From: Elliott, Stanice
Sent: Thursday, January 12, 2017 3:00 PM
To: 'David Soule'
Subject: RE: 6405 Picardia
Attachments: IMG_2098.JPG

Project Title: NUCE RESIDENCE **Building Permit #:** _____ **City Drainage #:** _____
DRB#: _____ **EPC#:** _____ **Work Order#:** _____
Legal Description: lot 30 block 8 volcano cliffs UNIT 22
City Address: 6405 PICARDIA PLACE NW

ENGINEER'S SEAL	6405 PICARDIA NUCE RESIDENCE	DRAWN BY WCWJ
	GRADING AND DRAINAGE PLAN	DATE 5-19-16
		21616-LAYOUT-5-18-16
5/18/16	1606 CENTRAL AVENUE SE SUITE 201 ALBUQUERQUE, NM 87106 (505) 872-0999	SHEET #
DAVID SOULE P.E. #14522		JOB # 21616

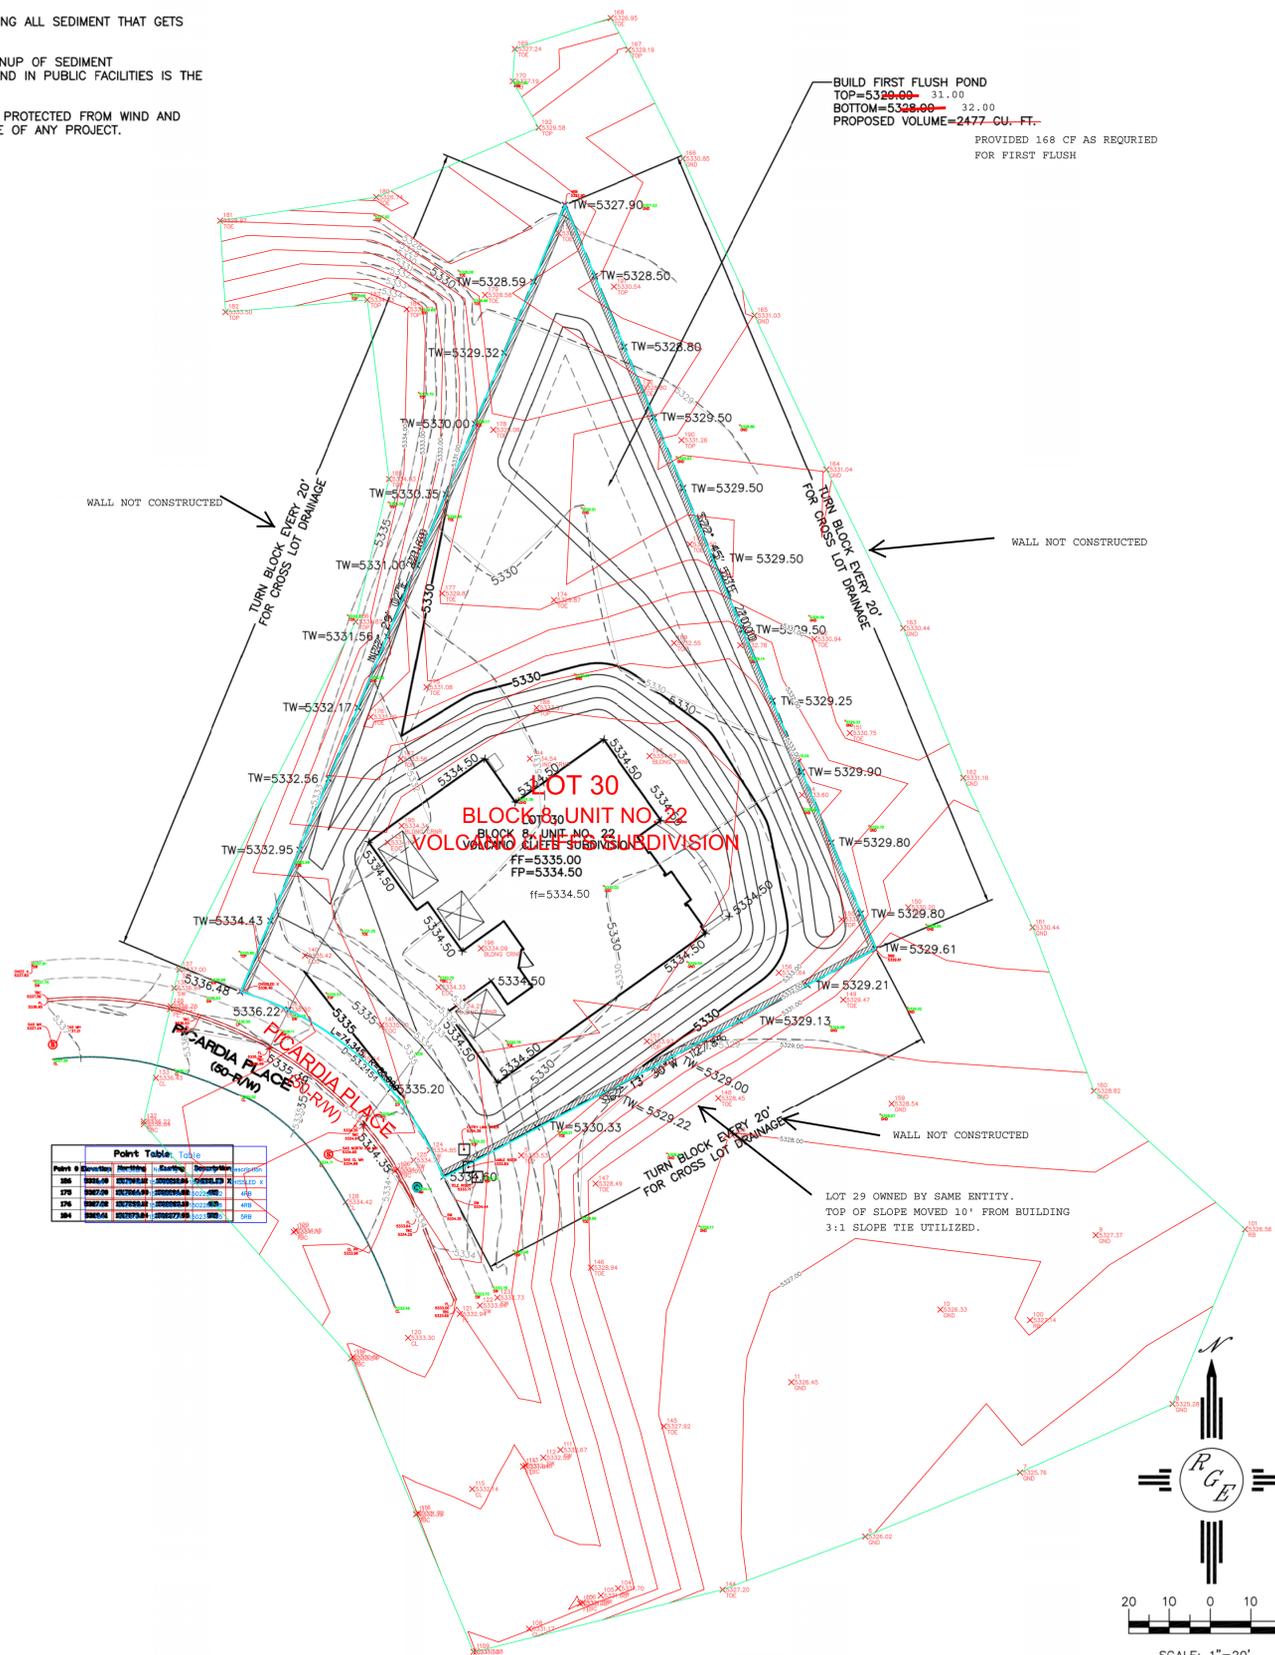
- The as-built points are difficult to read on the drawing.
- It appears dirt has been pushed on to another neighbors lot.
- The swale leading to the pond does appear to be present.
- The stake in the backyard is marked as corner of lot. Location does not appear to be a corner.

- The grades on site do not match grades on the approved grading and drainage plan
- Provide as-built grades
- Ensure that the grades match the approved SAD 228 Master Drainage Plan.

PERIMETER WALLS HAVE NOT BEEN CONSTRUCTED. ALL SLOPE TIES MEET 3:1 REQUIREMENT. GRADING EXTENDS TO LOT 29 WHICH HAS SAME OWNERSHIP. GRADING BY OTHERS ON ADJACENT LOTS HAS CHANGED THE GRADES AT COMMON PROPERTY LINES. THE ONSITE PONDING HAS BEEN SIGNIFICANTLY REDUCED BUT MEET THE FIRST FLUSH VOLUME REQUIREMENT AND SAD 228 DRAINAGE PLAN
